**HARNETT COUNTY ENVIROMENTAL HEALTH**

File/Permit #: EH2510-0007

SITE SKETCH

RE: Site meeting at lot 31, Honeycutt Hills SD, Harnett County, NC.

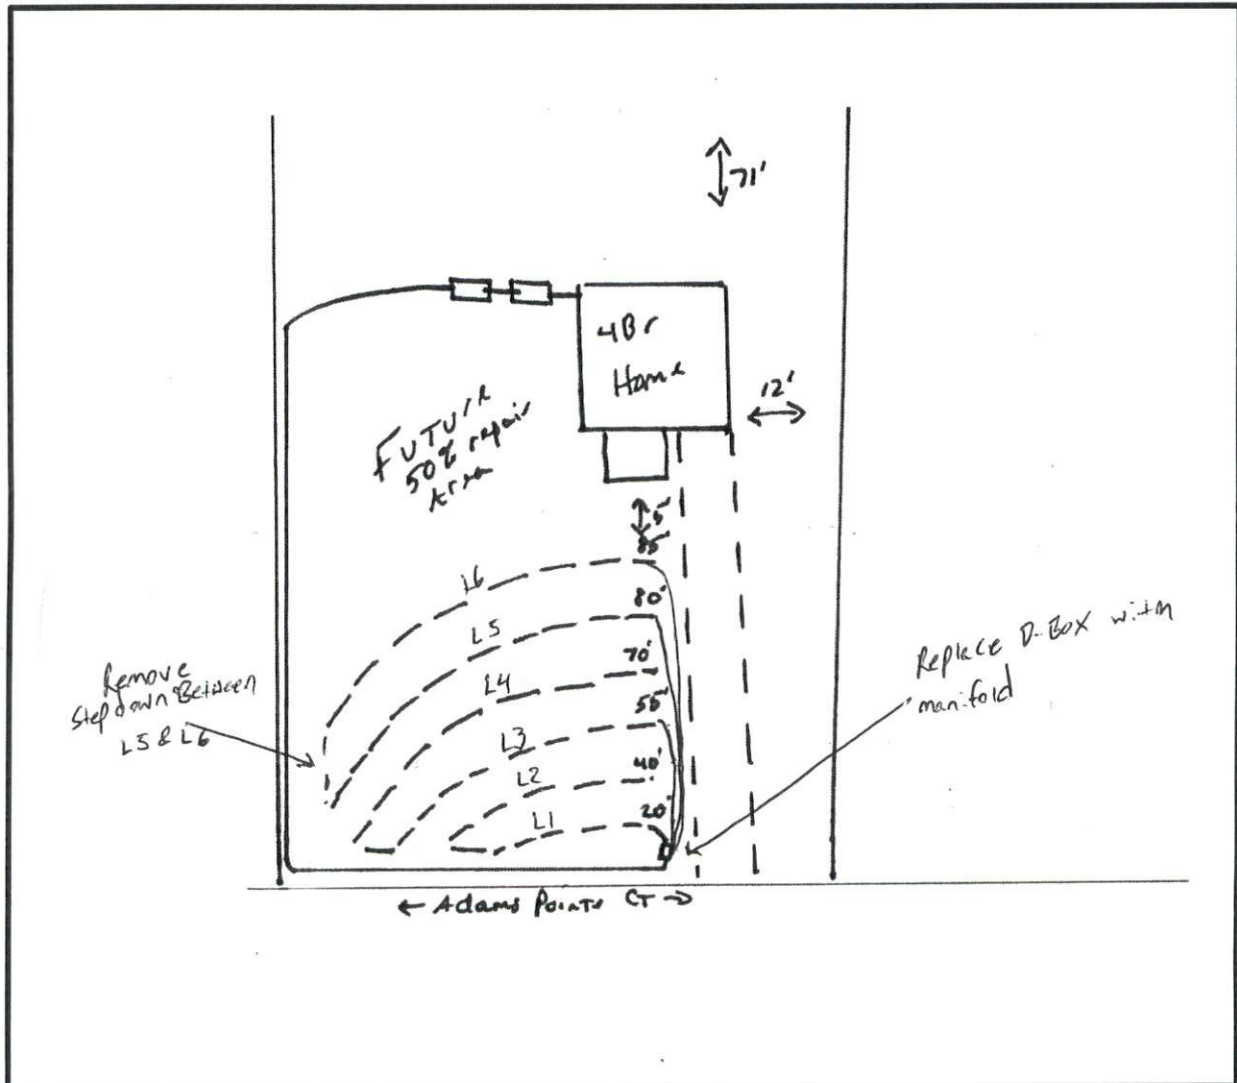
Must Follow Design Provided by Consultant. Must Add a Manifold with 4 Taps. Must Disconnect the Step-Down on Line L5 & L6 as Shown.
Must Replace the Pump Panel Box with a Aquaworx box for a time dosed system.

System components represent approximate contours only. The contractor must flag the system prior to beginning the installation to ensure that the proper grade is maintained.
